Subject: Munjoy Heights
 Preliminary Level III Site Plan Application
 Comment Response Letter

Woodard & Curran – Peer Review Memo

1. Summit Geoengineering Services, Inc. – Typical Wall Cross-Section Detail

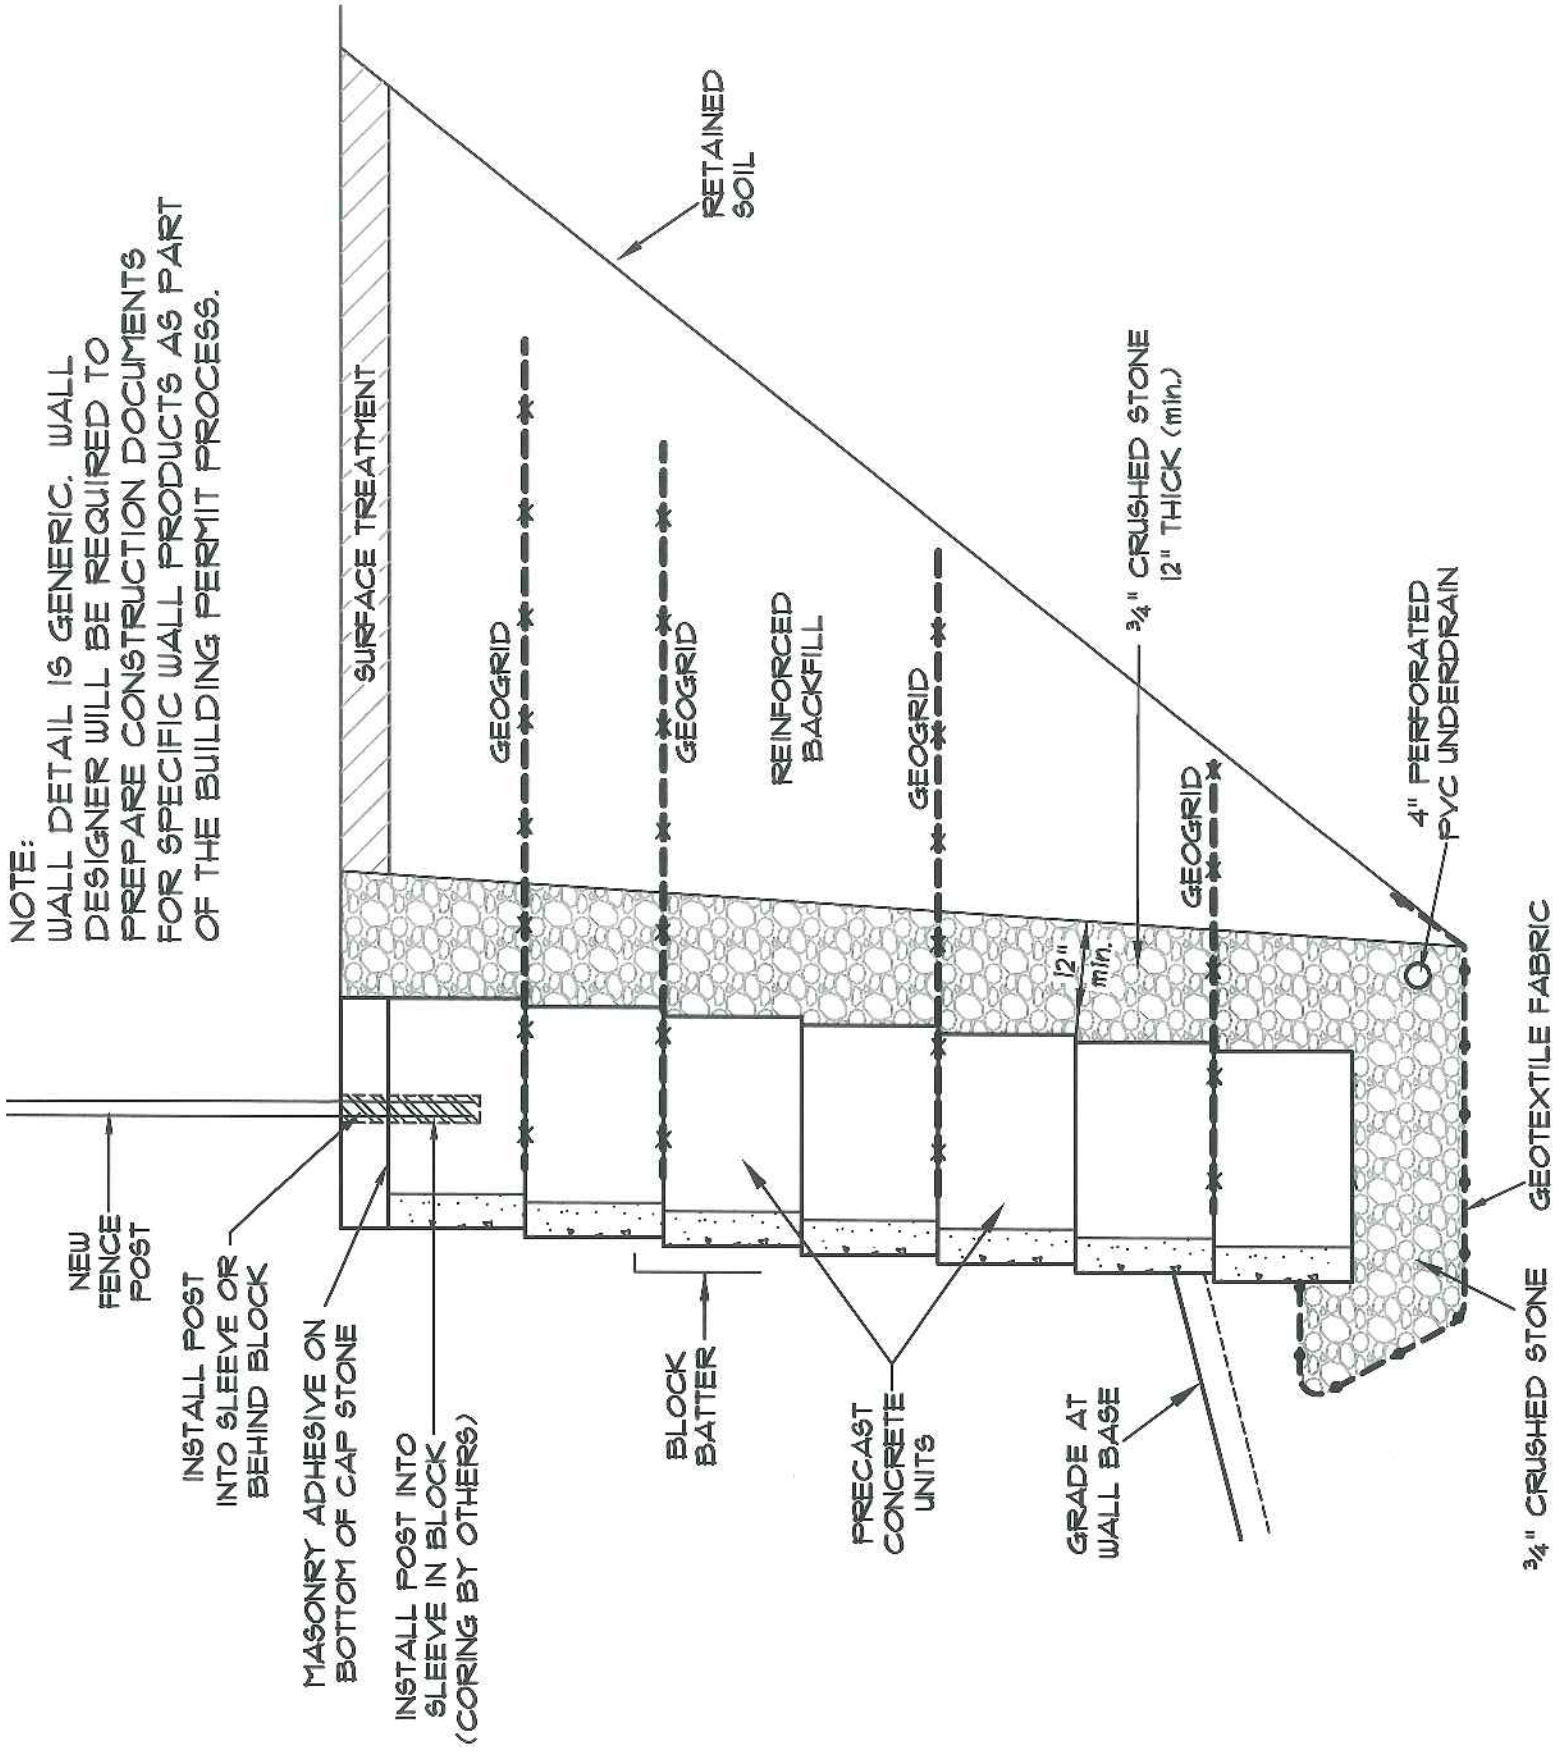
- 7) *The Preliminary Geotechnical Report has noted that the proposed grading at the site will require the construction of retaining walls near both the east and west property*

lines, and that the walls are estimated to be up to 25-feet high. The final submission should include specific details for these proposed walls, in addition to any associated assumptions and geotechnical design criteria.

Response: The following response is from Bill Peterlien, P.E. President & Principal Engineer of Summit Geoengineering Services, Inc. in an email October 15th, 2013. The Typical Wall Cross-Section Detail is attached to this letter.

"A typical retaining wall cross section is attached. Summit Geoengineering Services, the geotechnical engineer of record for this project, has been retained to design the retaining walls. SGS will consider the following conditions in the wall design.

1. Internal and external wall stability for all walls.
2. Global Stability for the east walls (fill side).
3. Method of constructing the west retaining walls - open cut and temporary or permanent shoring.
4. Consideration of the new building foundations in the design of the east walls.

A set of wall construction drawings stamped by a Maine PE will be prepared prior to construction. We anticipate submitting the wall drawings along with other documents submitted to obtain a building permit for the project."

NOTE:
 WALL DETAIL IS GENERIC. WALL
 DESIGNER WILL BE REQUIRED TO
 PREPARE CONSTRUCTION DOCUMENTS
 FOR SPECIFIC WALL PRODUCTS AS PART
 OF THE BUILDING PERMIT PROCESS.
